DEPARTMENT OF TRANSPORTATION**National Highway Traffic Safety Administration****49 CFR Part 572**

Anthropomorphic Test Devices; Six-Year-Old Crash Test Dummy**AGENCY:** National Highway Traffic Safety Administration (NHTSA), Department of Transportation.**ACTION:** Final rule; response to petitions for reconsideration.

SUMMARY: This document responds to petitions for reconsideration of the final rule that adopted a new, more advanced 6-year-old child dummy (HIII-6C). That final rule was published January 13, 2000 (65 FR 2059, Docket No. NHTSA-99-6714). Adopting the dummy was the first step toward using the dummy to evaluate the safety of air bags for children. The petitions are granted in part and denied in part.

Figure N 2
NECK FLEXION TEST SET-UP SPECIFICATIONS

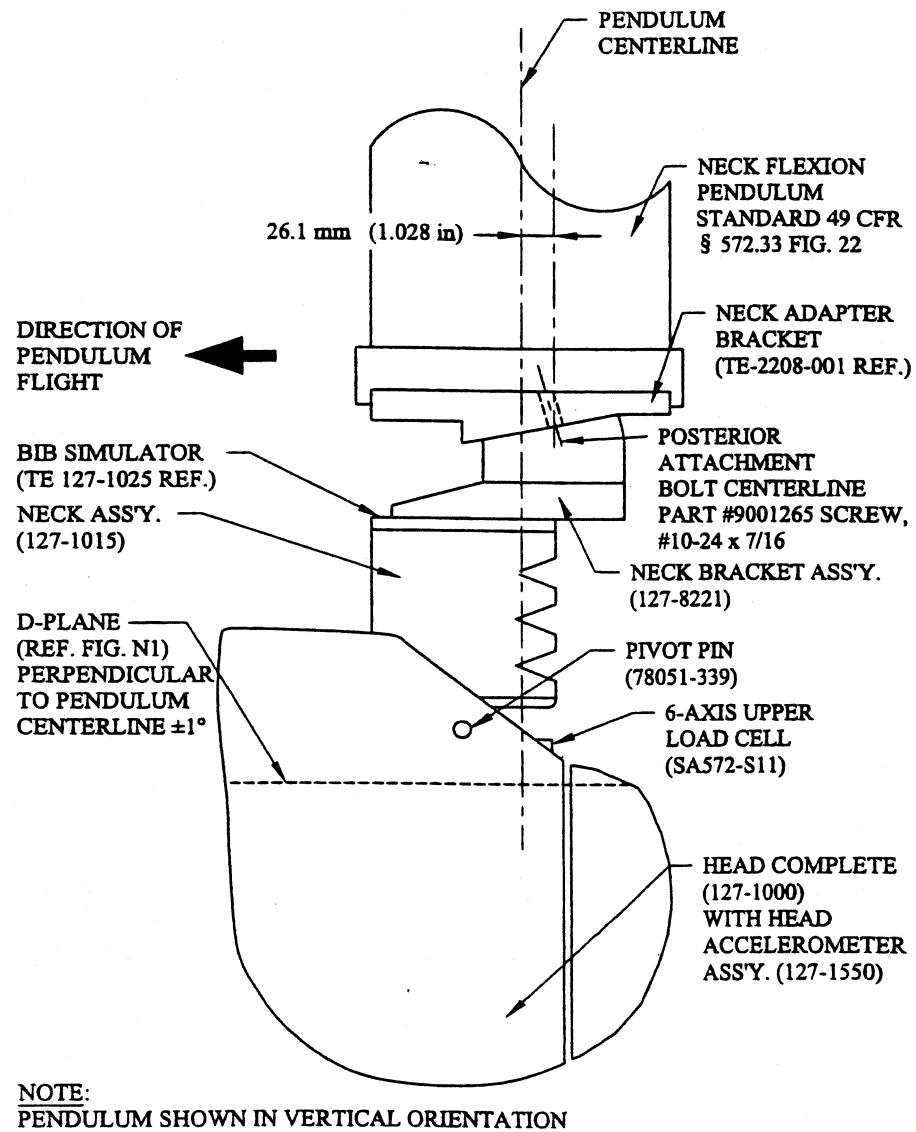
- Figure N2: (1) Relocate the 26.1 mm reference to the centerline of the posterior attachment bolt to reflect dimensional proportionality; (2) change reference from "Neck Flexion Pendulum 46 CFR 572.33 FIG 22" to "Neck Flexion Pendulum 49 CFR 572.33 FIG 22"; and (3) add part number for bolt "#9001265 Screw, SHCS #10-24 x 7/16".

Figure N 3

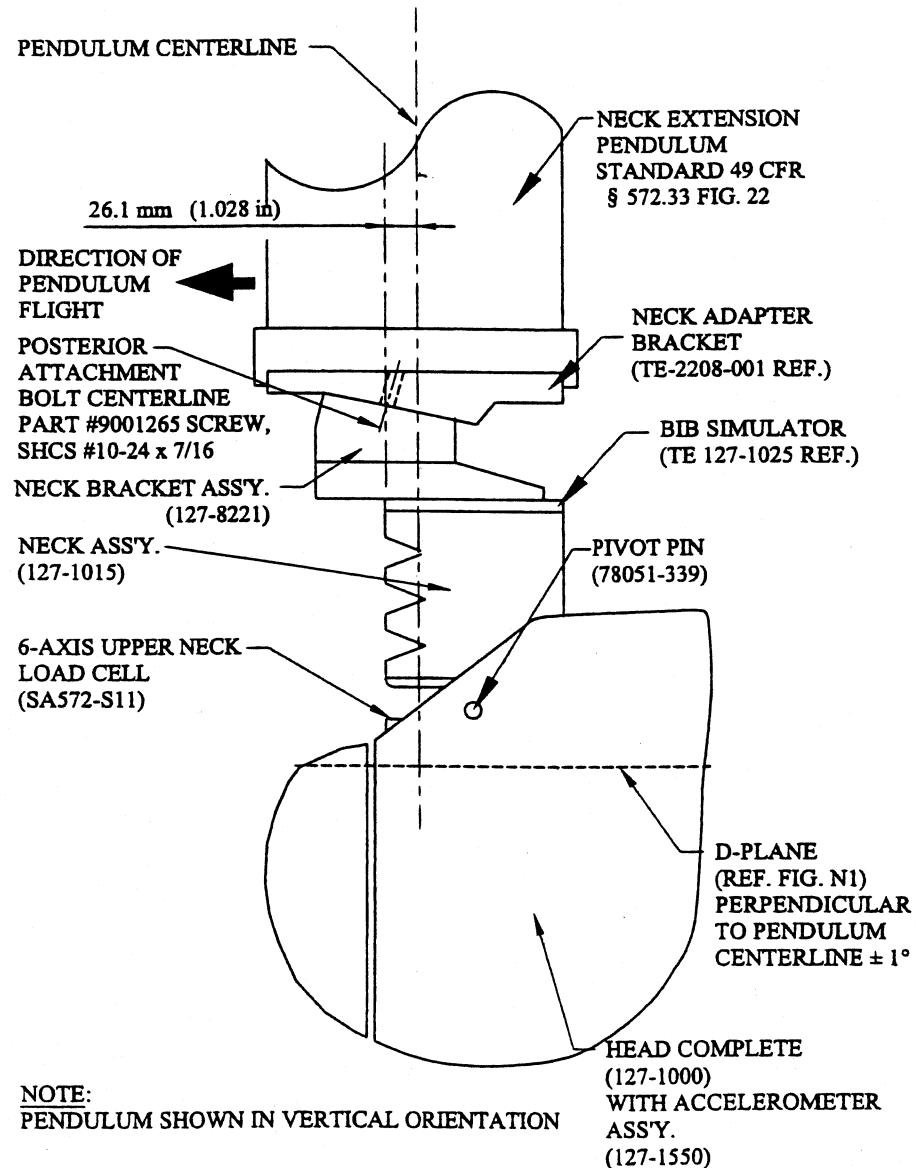
- Figure N3: (1) relocate the 26.1 mm reference to the centerline of the posterior attachment bolt to reflect dimensional proportionality; and (2) add part number for bolt "#9001265 Screw, SHCS #10-24 x 7/16".

FIGURE N 6
KNEE IMPACT TEST SET-UP SPECIFICATIONS

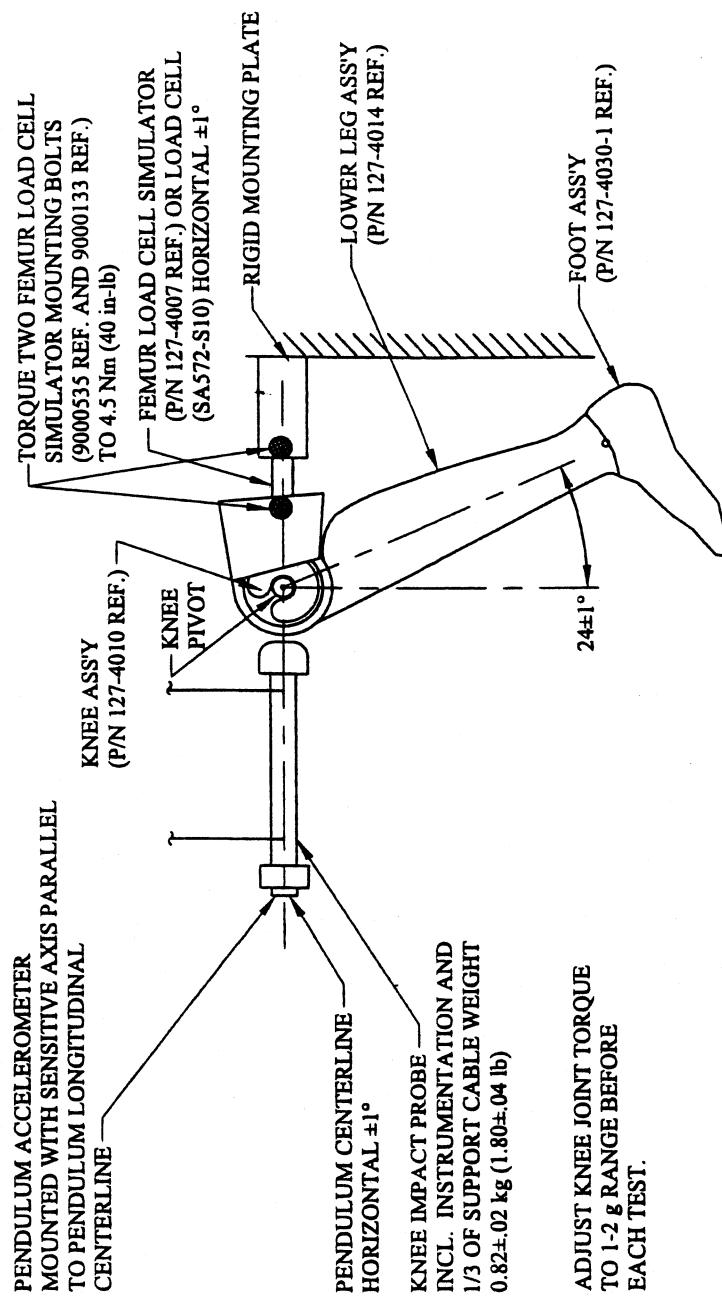
- Figure N6: (1) remove note SA572-S4; and (2) change the weight tolerance on the knee probe from "0.82 ± 0.01 kg (1.80 ± .02 lb)" to "0.82 ± 0.02 kg (1.80 ± .05 lb)".
